Nummer: **2025-04 Info Jyro Safire 3 Steuerleinen**

Service bulletin number: 20180301-V2

Subject: Safire 3 Brake Line Configuration Modification And Mandatory Inspection

SAFIRE 3 MODIFICATION GUIDE

NEW BRAKE TABS CONFIGURATION

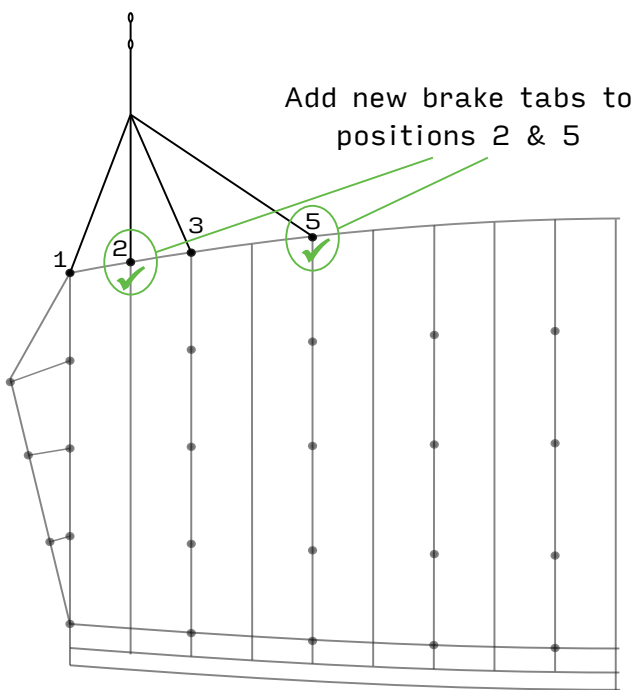
1. Brake Tab Configuration
 - a. Confirm that the canopy's brake tabs follow this sequence: 1-2-3-5 (see diagram below)
2. Lineset Check
 - a. Verify that the canopy has been relined with the current lineset
 - b. Quick tip: Measure A1 and A2 lines - they should be the same length in the current trim

EXISTING BRAKE TABS CONFIGURATION

You can request a free modification kit from the JYRO Sales team. This includes the current lineset and extra brake tabs. The modification entails removing brake tabs at positions 4 & 6, and installing new tabs at positions 2 & 5. The canopy should be relined with the current lineset. The old lineset must be disposed of.

NOTE: Brake tab positions are numbered along each rib, starting with the outside corners of the tail as position 1.

- Brake tabs are installed at the 1-2-3-5 positions.
- Canopy has been relined with the latest lineset, this can be verified by checking if the A1 and A2 lines are the same length.

If either check fails, the canopy should be grounded until the canopy has been updated to the current configuration with the help of your local rigger or JYRO.

INSTALLATION SPECIFICATIONS

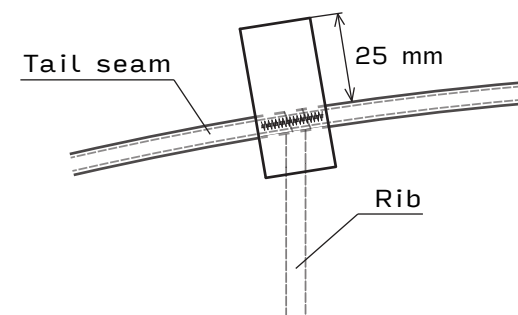
BRAKE TAB: Type III, 3/4", NAT, MIL-T-5038

100 mm

BARTACK: 42 stitches, centre start and stop

THREAD: Tkt 60 (tex 45), Silver, bonded continuous filament nylon 6.6
